Three Mile Island Unit 2  
Response to ACES Questions

MEMORANDUM FOR: W. Regan, Chief, Environmental Projects Branch 3  
FROM: L. G. Hulman, Chief, Hydrology-Meteorology Branch  
SUBJECT: RESPONSE TO AGENCY DES COMMENTS

PLANT NAME: Three Mile Island Nuclear Generating Station, Unit 2  
LICENSING STAGE: OL  
DOCKET NUMBER: 50-320  
REQUESTED COMPLETION DATE: October 15, 1976  
REVIEW STATUS: Hydrologic Engineering Section, HME -- Complete

Three Mile Island Nuclear Station (TMI)  
Docket Nos. 50-289 and 50-320

SURFACE FEATURES OF TOE PROTECTION - SURVEY RESULTS - G.A.I. JUNE 1976

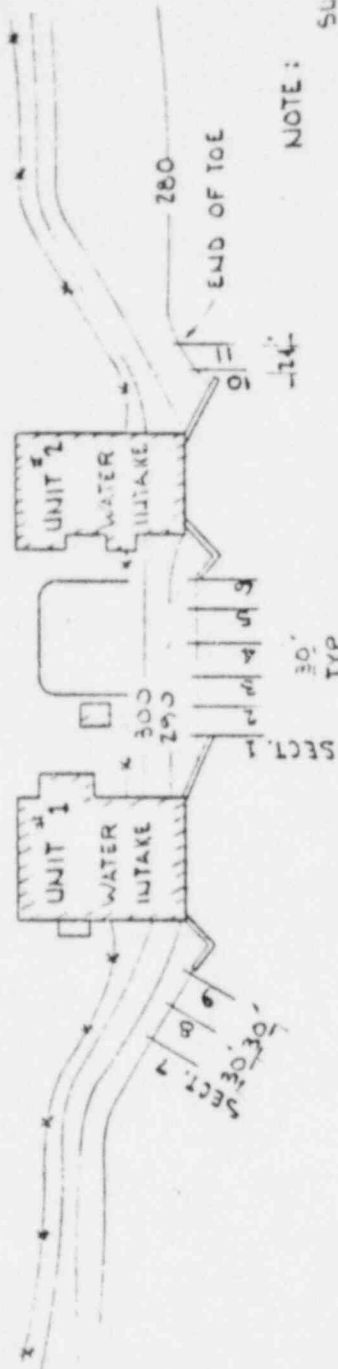
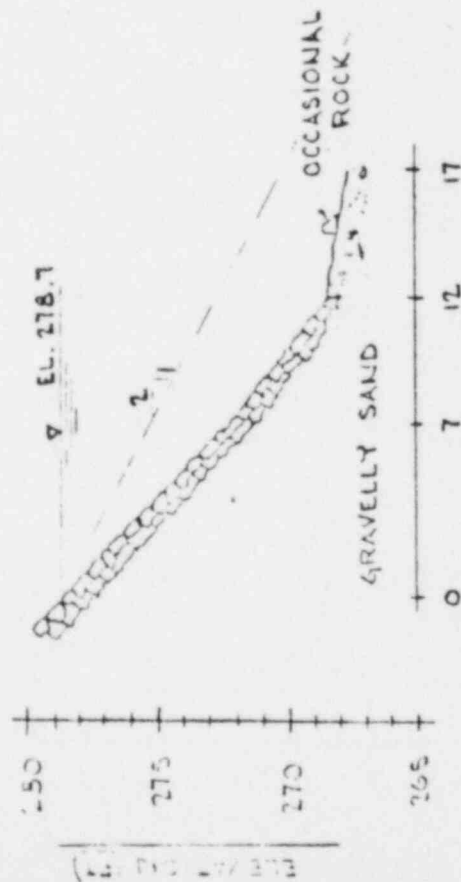
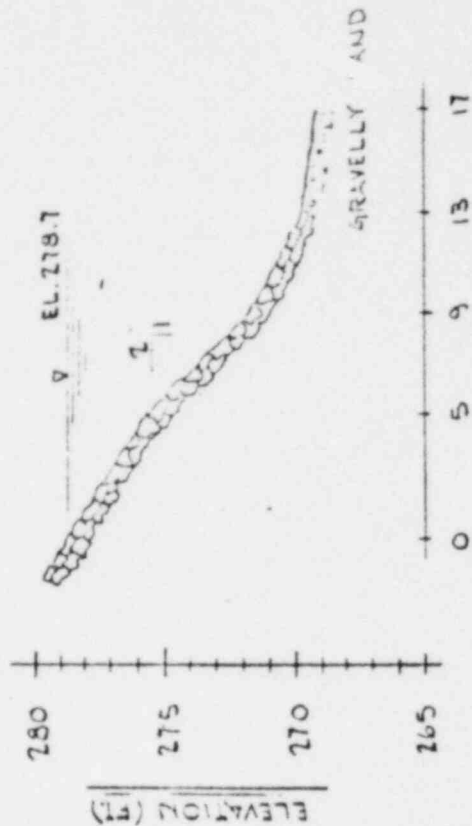
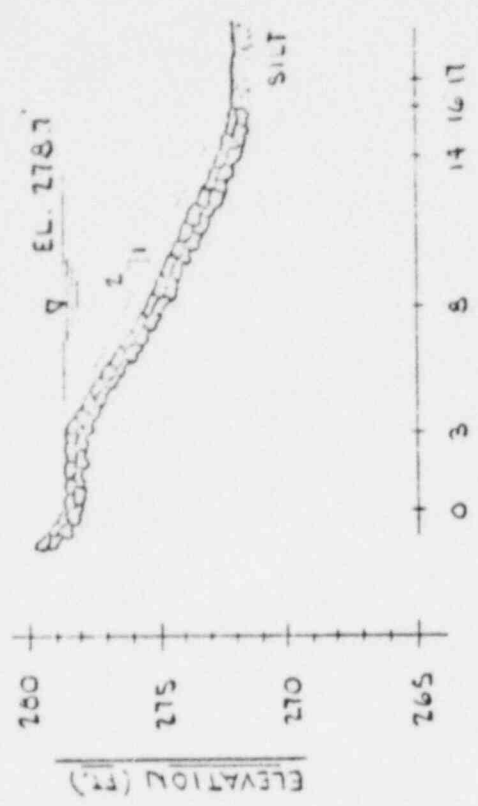
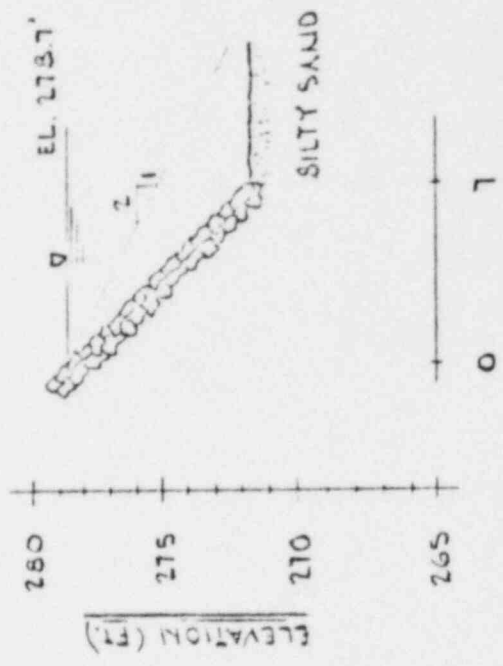
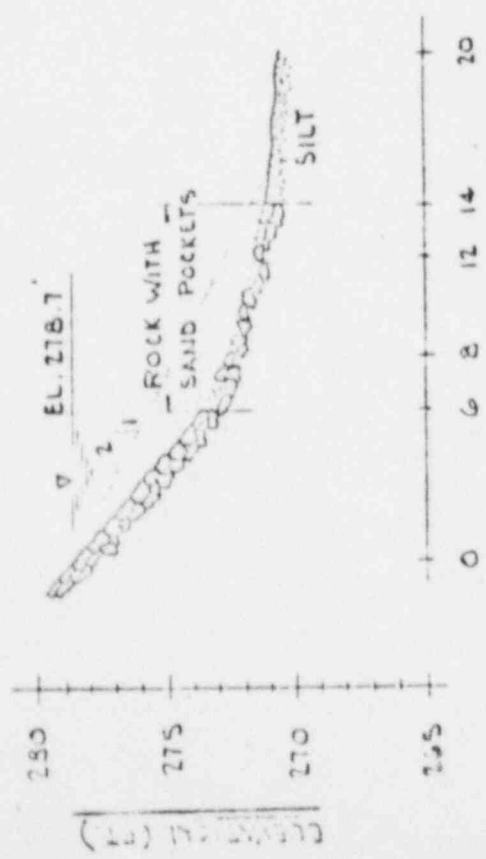
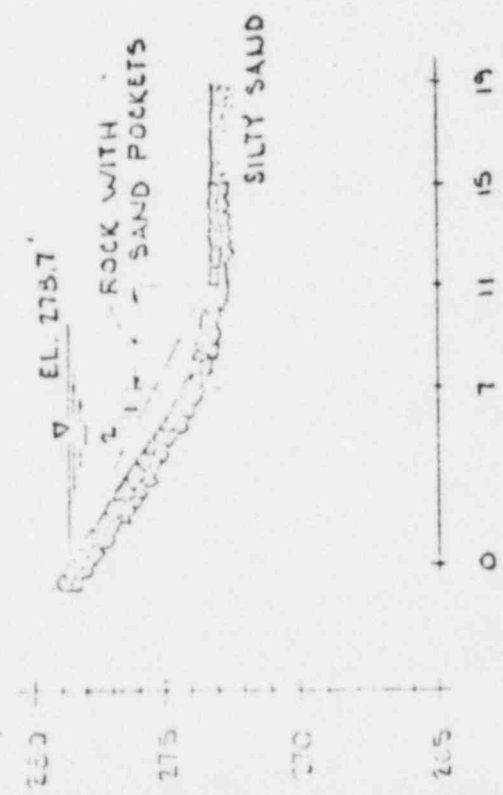
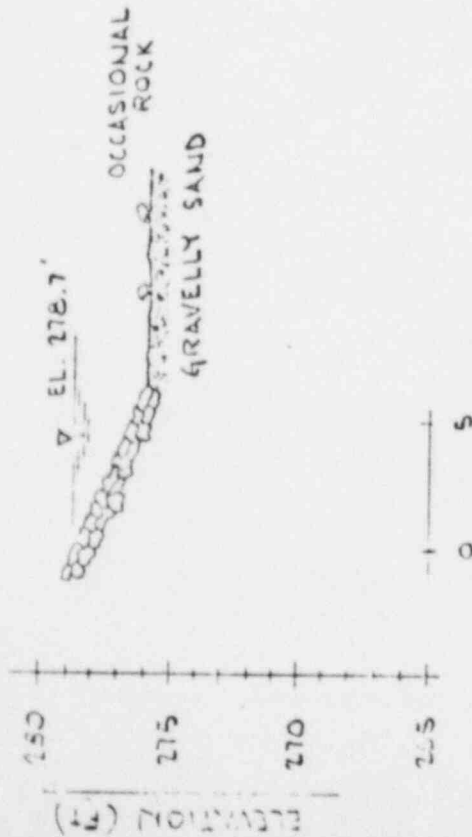
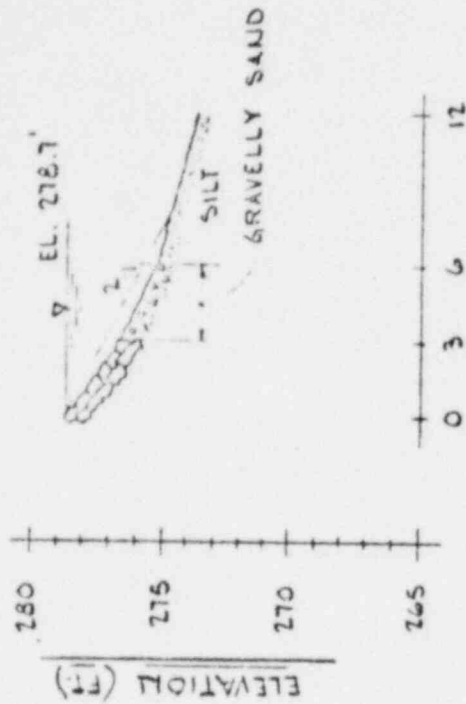
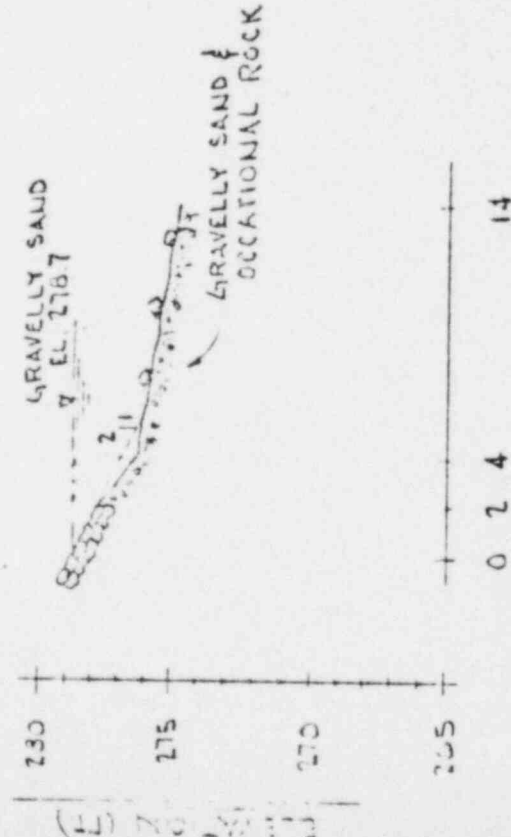
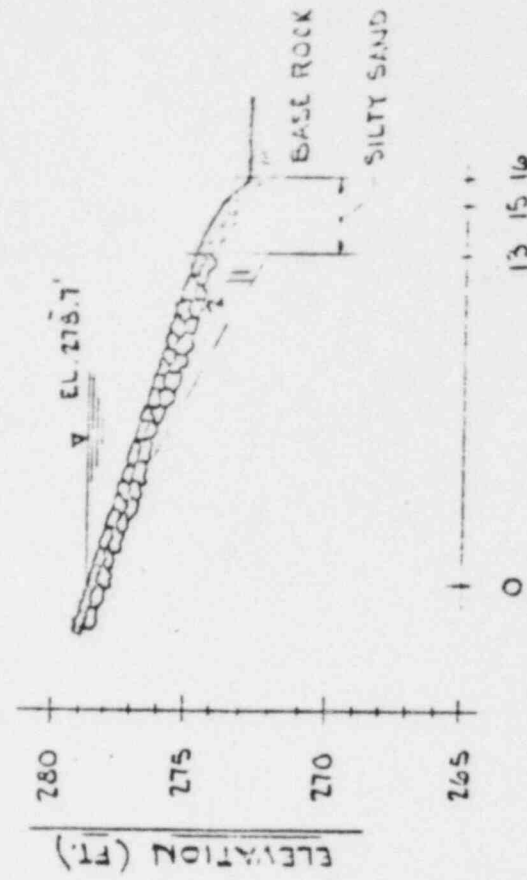
Attached are drawings which show the results of the post repair toe survey recently conducted. It can be seen from these drawings that between the intake structures the dike toe slopes more steeply than specified. Therefore, we plan to correct the toe slope at the same time that repairs to dike's east exposure are accomplished. These repairs will be completed by April 30, 1977.
